**HISTORIC LANDMARK COMMISSION**  
**PERMITS IN NATIONAL REGISTER HISTORIC DISTRICTS**  
**NOVEMBER 2, 2022**  
**HR-2022-152804**  
**TRAVIS HEIGHTS - FAIRVIEW PARK**  
**201 PARK LANE**

Construct a new residence.

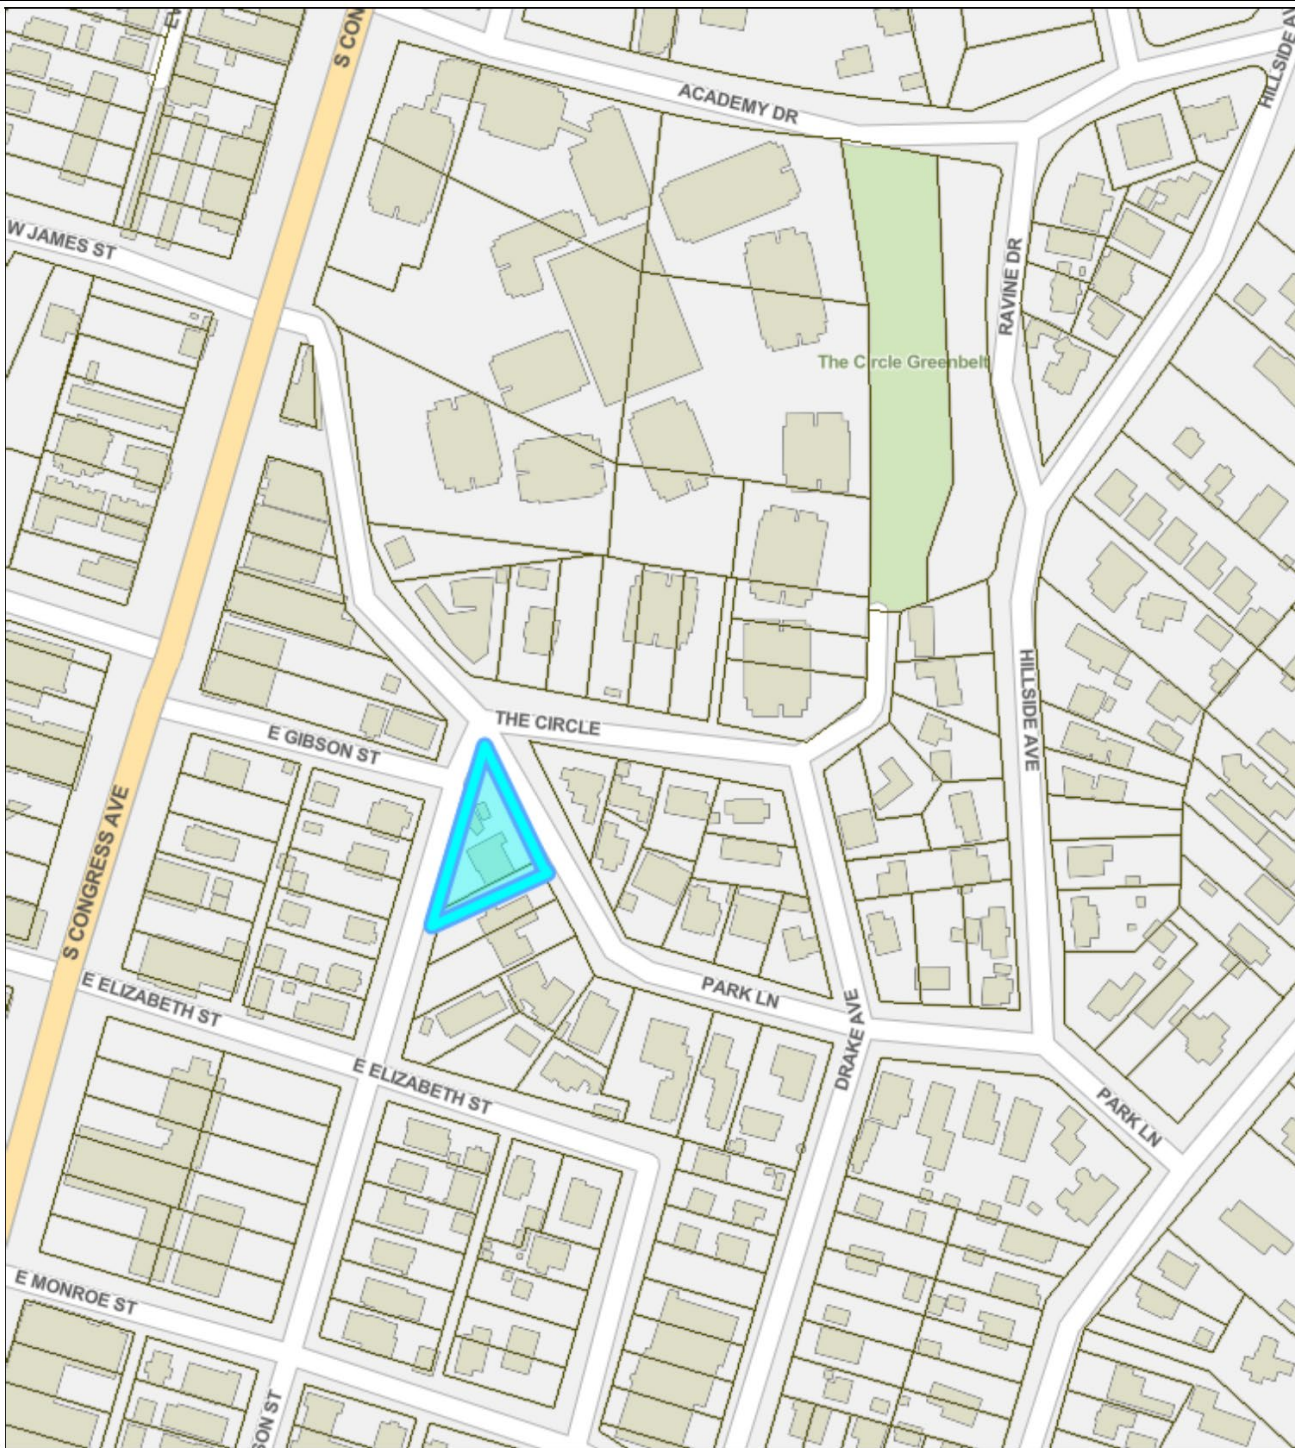
Modify roofline and fenestration to be more in keeping with the neighborhood. Add more fenestration and use fewer masonry elements, taking cues from the surrounding contributing buildings (e.g., lap siding, shingle roofing, gabled or hipped roofline). Do not use a shed roof on the dormer, though the dormer position at the rear of the building is favorable. Reconsider vertical siding, as it appears to overwhelm the building form in renderings.
